ROCKER ARM SHAFT

Application of Modifications

This changes have been applied on the production models starting with the following engine serial numbers.

Fig. 1 (1) Cylinder head cover
(2) Sealing washer
(3) Right rocker arm shaft
(4) Left rocker arm shaft

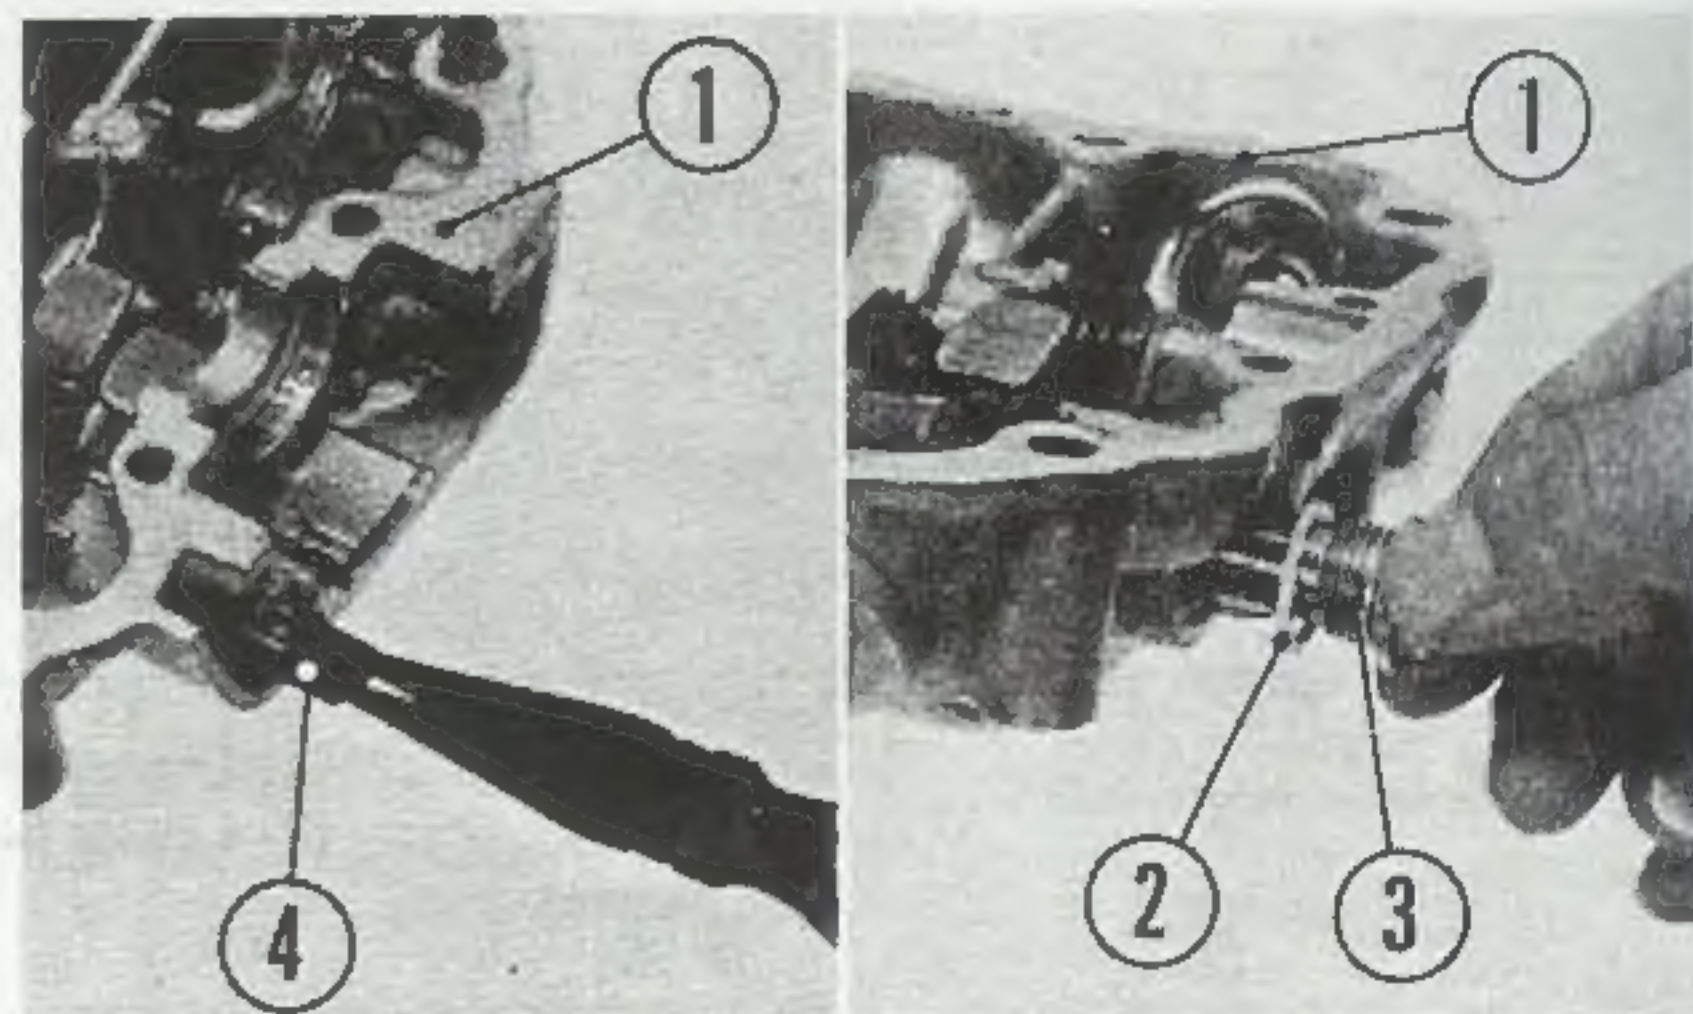
Except that Right rocker arm shaft is removed only loosening bolt.
